Summary of Environmental Impacts: Removal of T-101, Addition of Alt-4, and T-109 changing from a V120 to a V110

Blazing Star Wind Farm 2 Lincoln County, MN

TO: Brie Anderson (Merjent)
FROM: Ryan Haac
Eddie Duncan, INCE Bd. Cert.
DATE: August 19, 2019
SUBJECT: Updated sound propagation modeling results for Blazing Star 2

Subject: Blazing Star 2, LLC Shadow Flicker Effects from Turbine Moves

Turbine ALT-4 Addition Vestas V110/V120

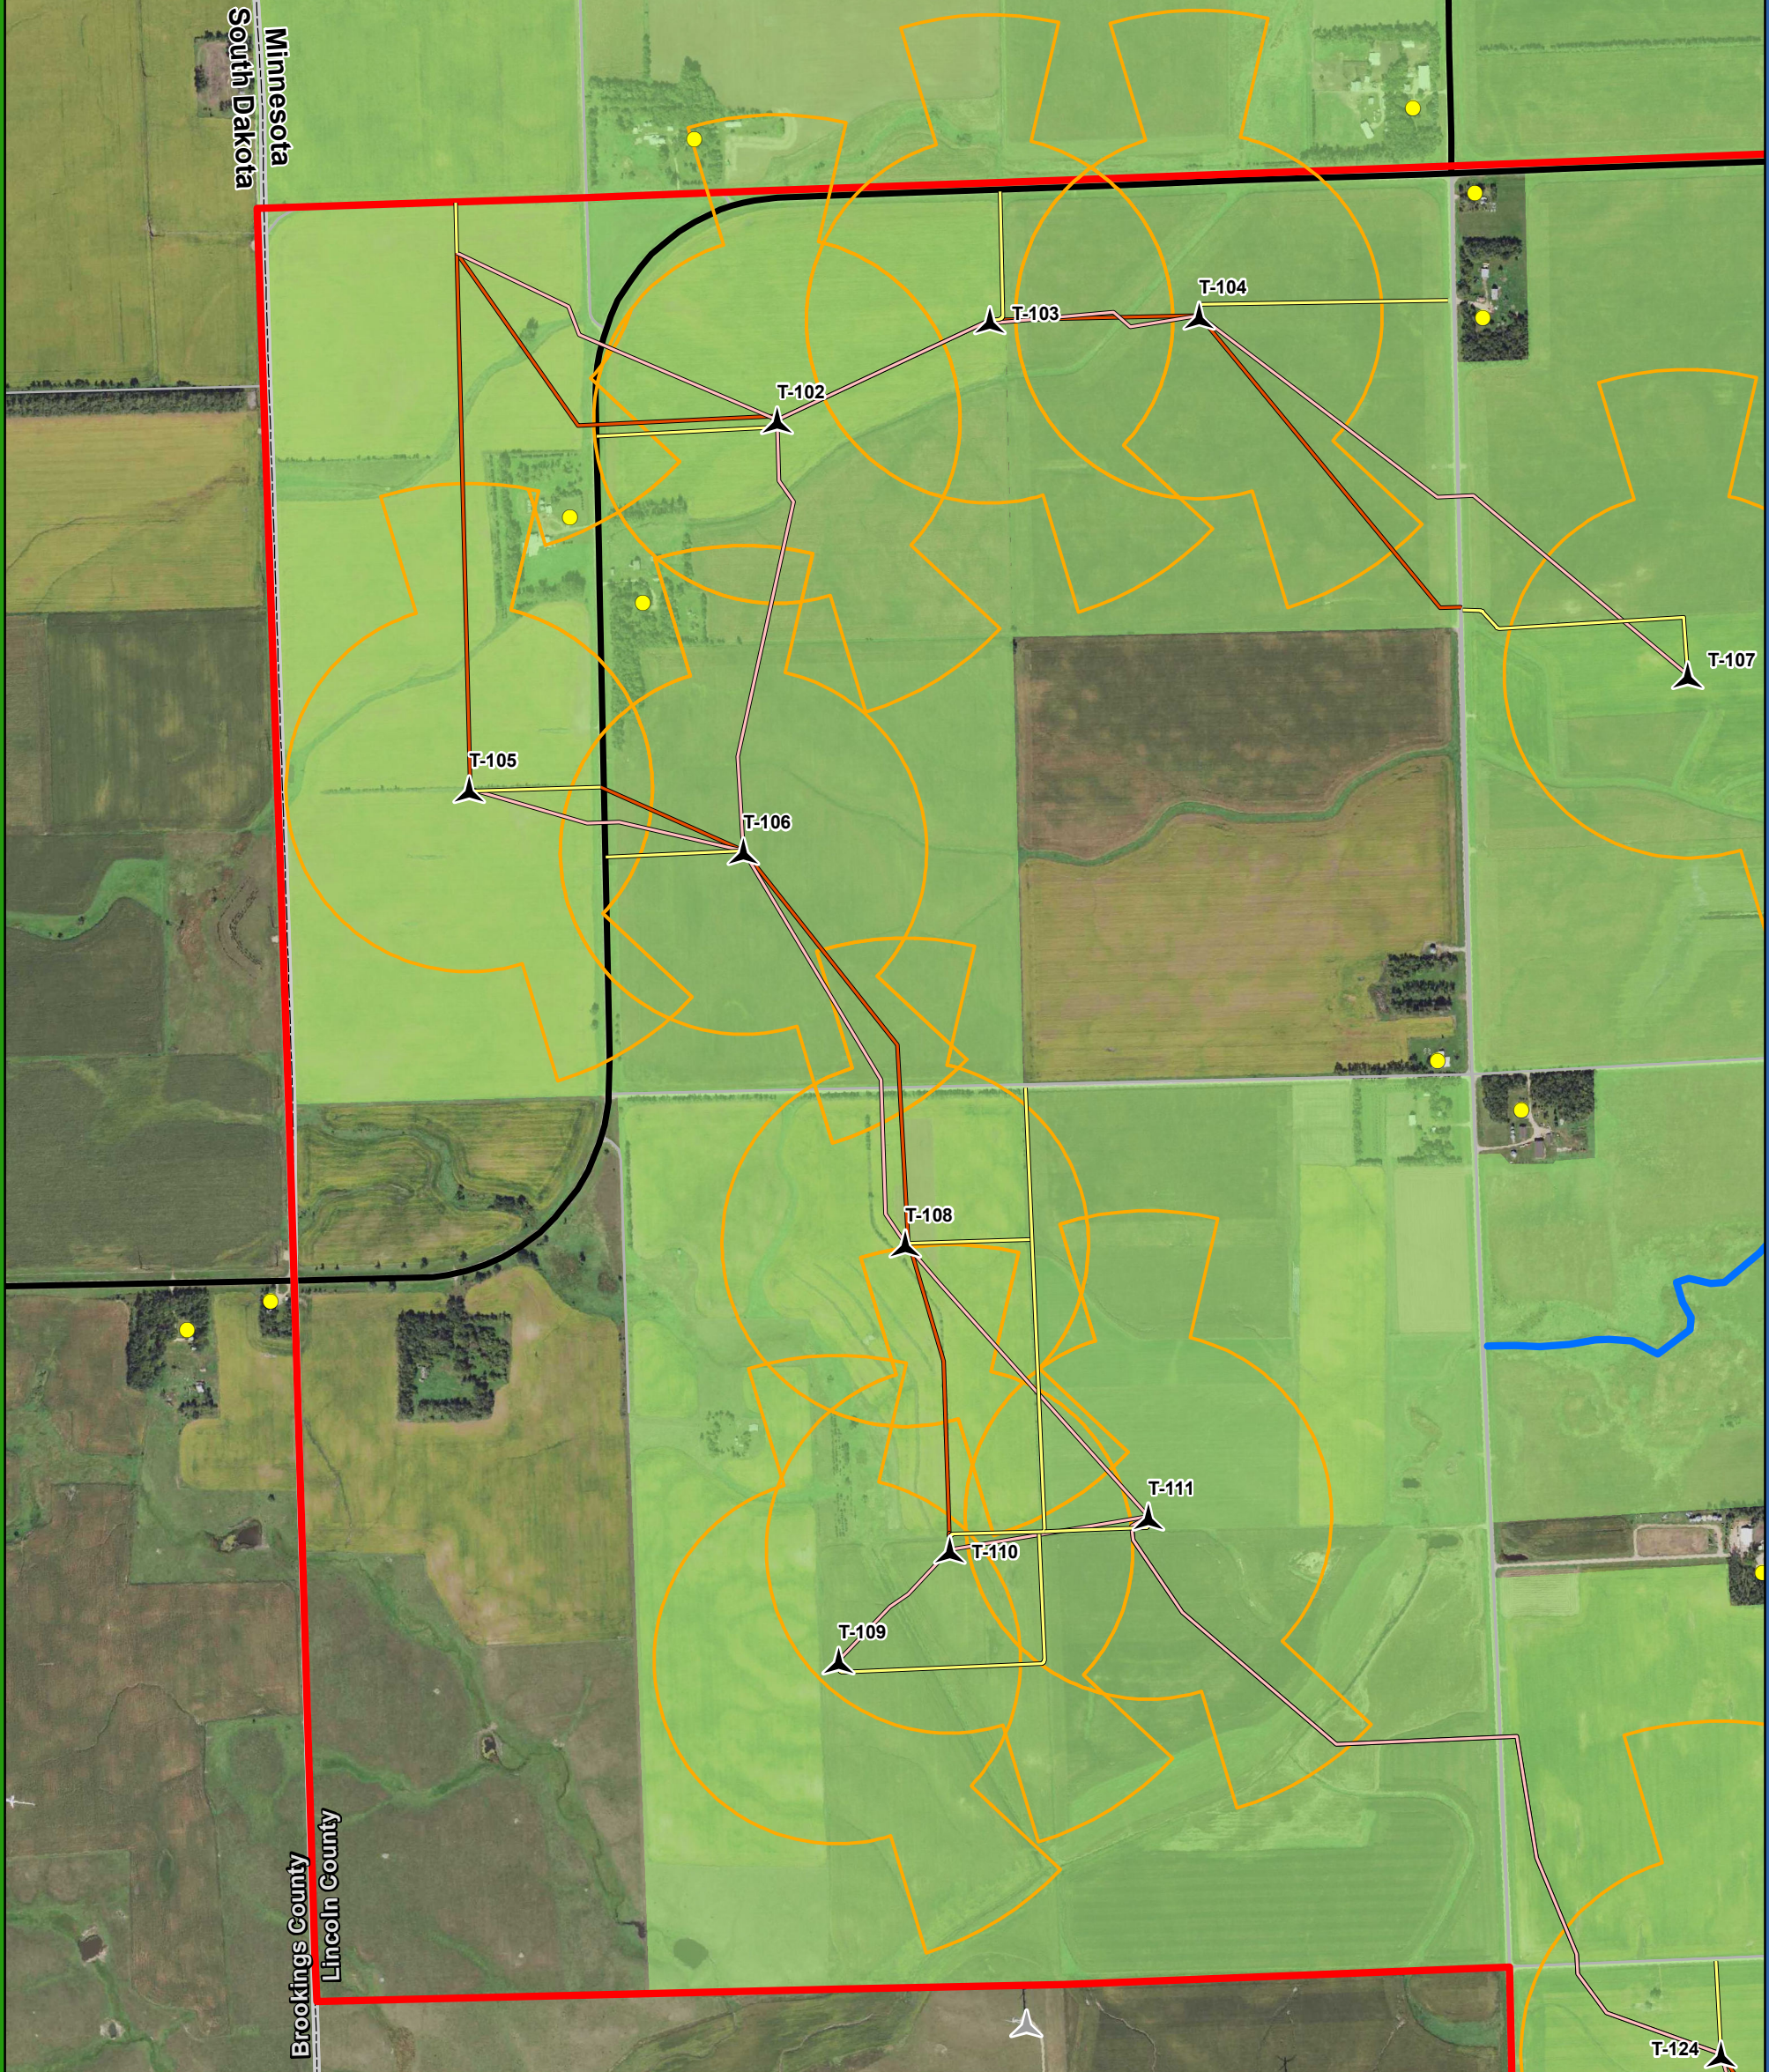
8.16: Surface Waters and Floodplain Resources	-	The access route to Alt-4 would cross PWI watercourse Yellow Medicine River, South Branch (M-055-146-042). The access would be culverted and Xcel Energy will coordinate with the Minnesota Department of Natural Resources for Public Waters Crossing license	-

8.17: Wetlands	-	There are NWI mapped wetlands associated with the PWI crossing. Xcel Energy had previously completed wetland delineations in its evaluation of this alternate	-

FIGURE 1: MAP OF MODIFICATIONS TO WIND TURBINE SOUND PROPAGATION MODEL

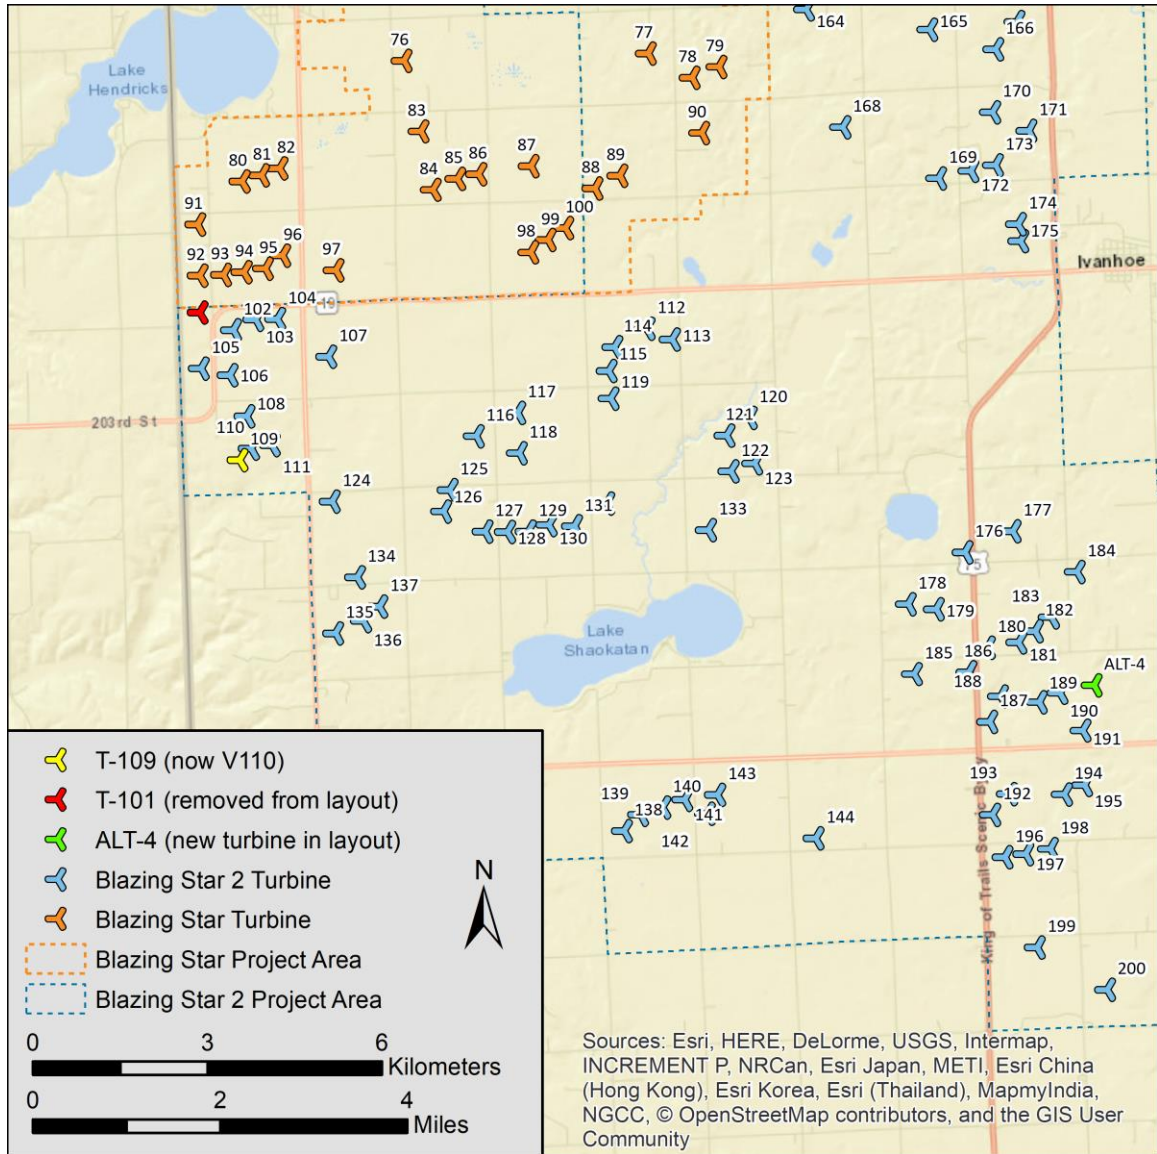
- Removed T-101 (Vestas V110)
- Added Alt-4 (Vestas V120)
- Changed the turbine model of T-109 from the Vestas V120 to the Vestas V110

Based on the model previously reported in the Noise Compliance Report¹ for the Project, modeled sound levels at residences near T-101 (removed) and T-109 (changed from V120 to V110) only decreased in sound level. Modeled sound levels increased at residences near the new turbine (ALT-4), but turbine-only and turbine plus background (combined) L₅₀ sound levels meet the 50 dBA L₅₀ limit set out in Minnesota Rules Chapter 7030. A summary of the results for the residences closest to the new turbine (ALT-4) is provided in Table 1.
